Sharing on Mechanical Issues

Timber Mock Up & Sample Unit Observations

Sanitary Pipes

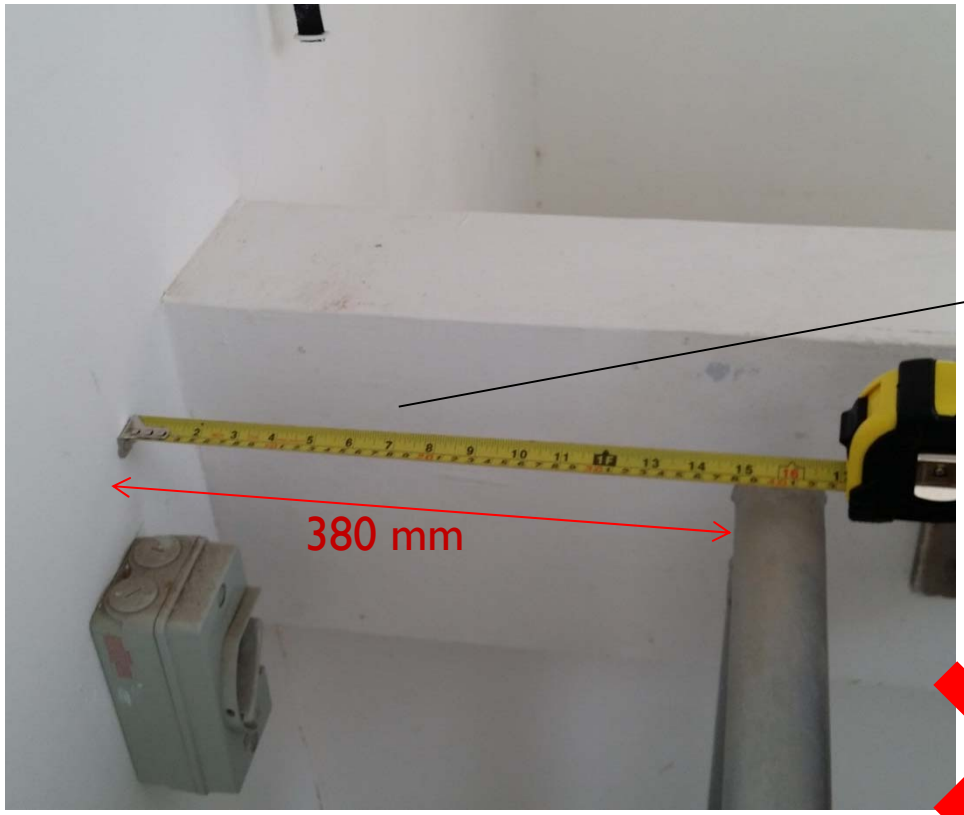
- Orientation of Cleaning Eyes Provided Along Discharge Pipes to be Accessed Easily

Floor Waste (Kitchen)

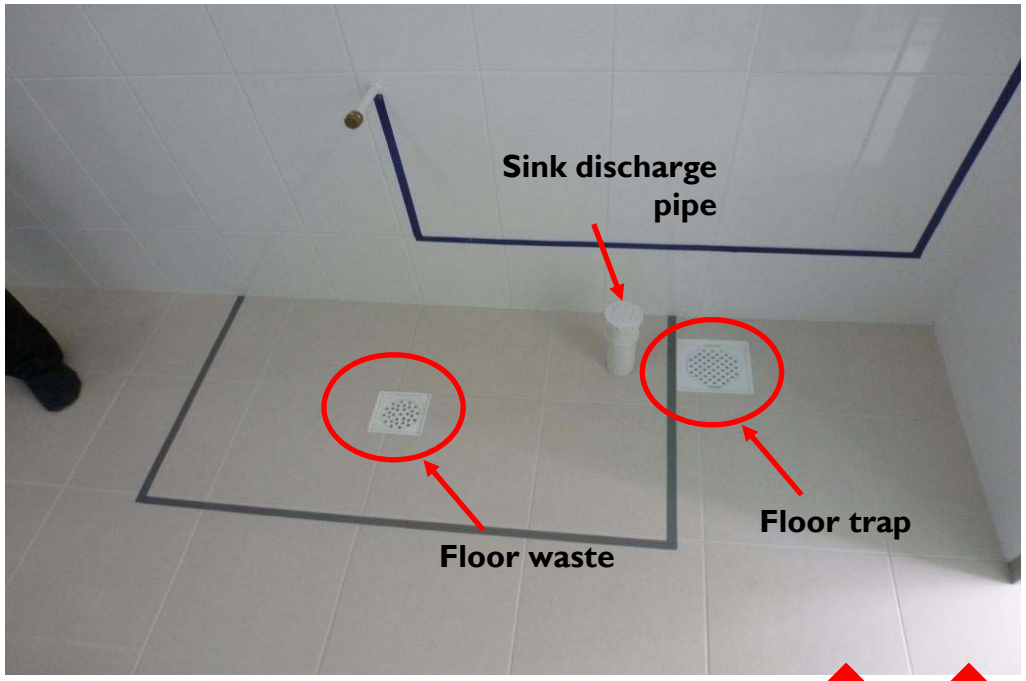
- Additional floor waste in the kitchen not HDB norm

Discharge Pipe in Kitchen

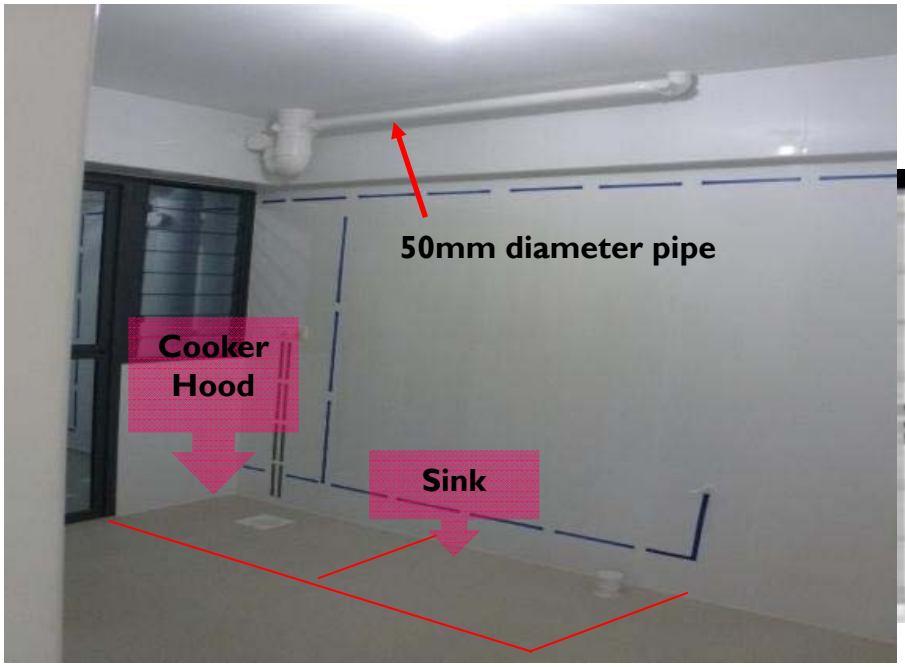
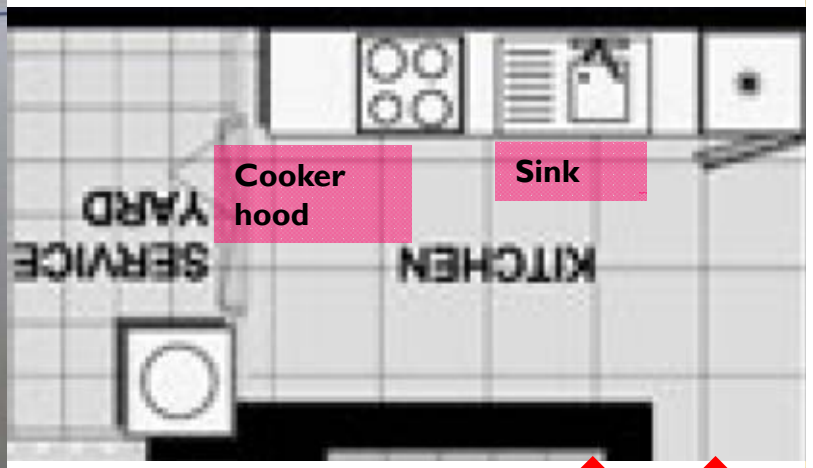
- Discharge pipe runs across the kitchen
- Unsightly and reduces cabinet storage space
